**ROGERS STATE UNIVERSITY**  
**1701 W. WILL ROGES BLVD.**  
**CLAREMORE, OK 74017**

**RE: Addendum No. 2**

**PROJECT: Request for Bid – Phase 2 Roof Replacement - RFB 2021-03**

**DATE OF ADDENDUM ISSUE: February 10<sup>th</sup>, 2021**

Bushyhead Fieldhouse

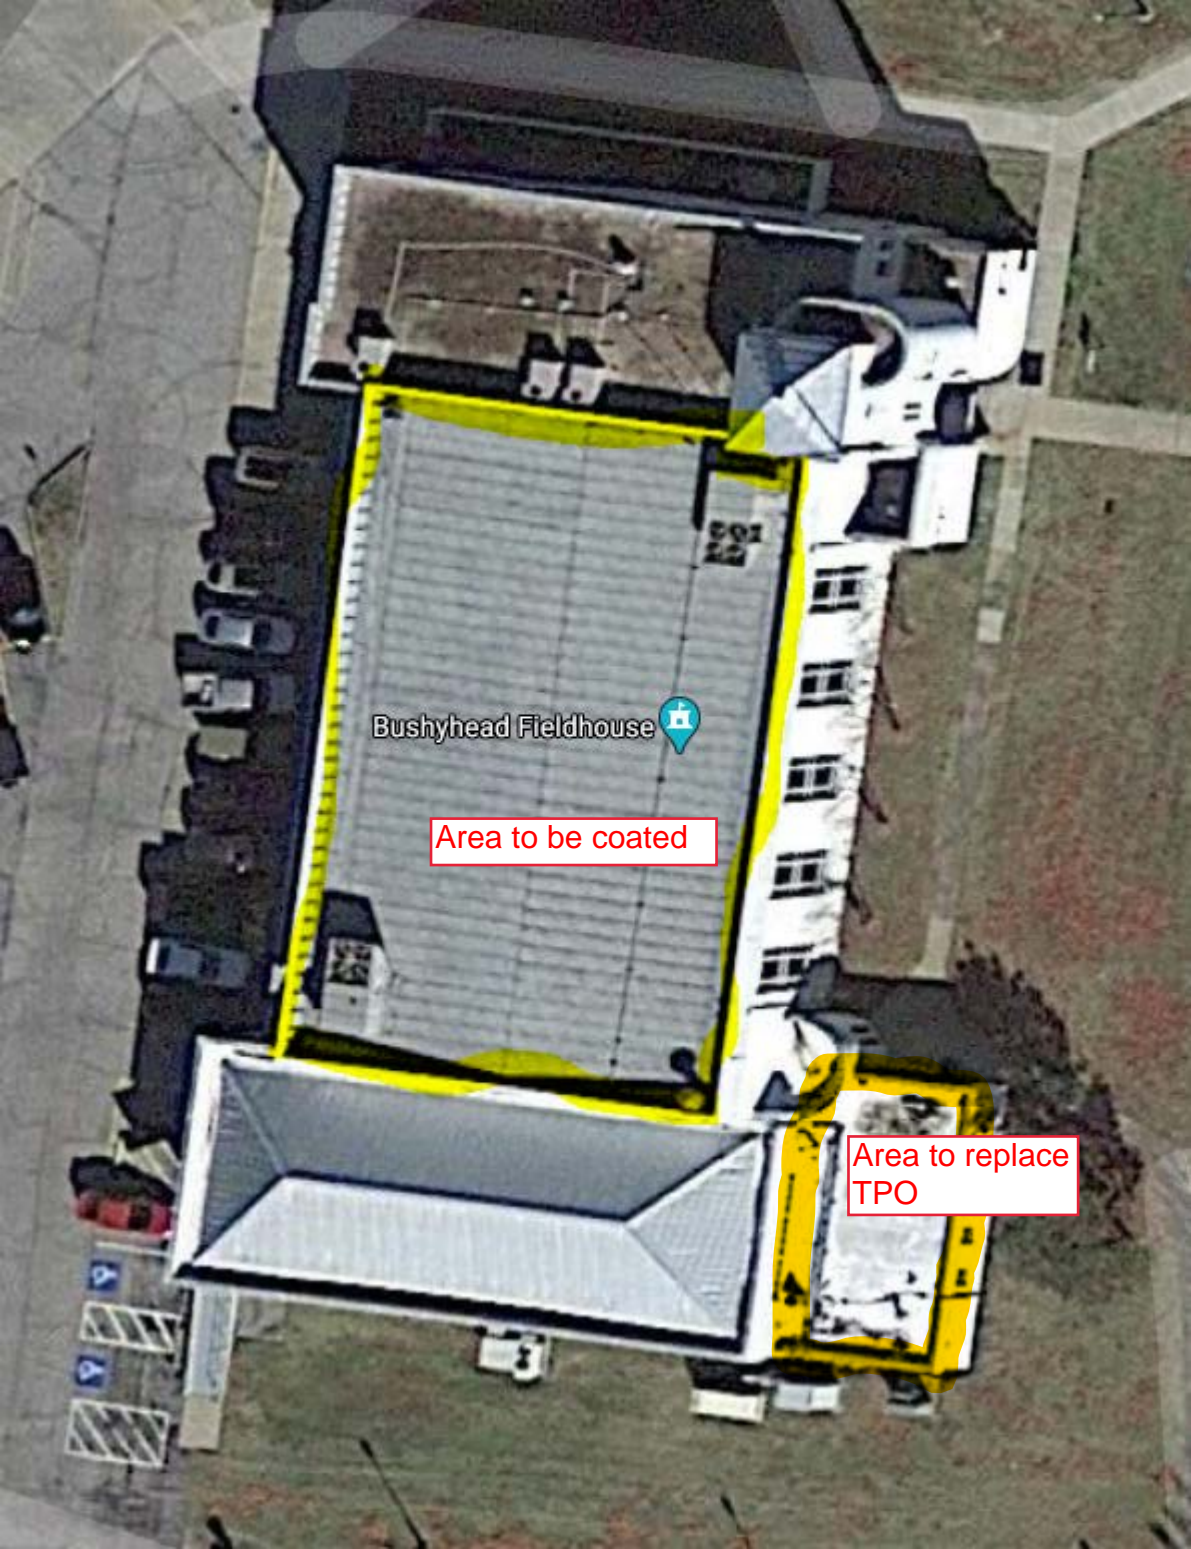
**Item No. 3 – Bushyhead – Questions: what roof is to be coated which is to be replaced with TPO. Answer: gym roof is coated, roof on southeast corner to be replaced, (see attached view)**

Area to be coated

Area to replace  
TPO
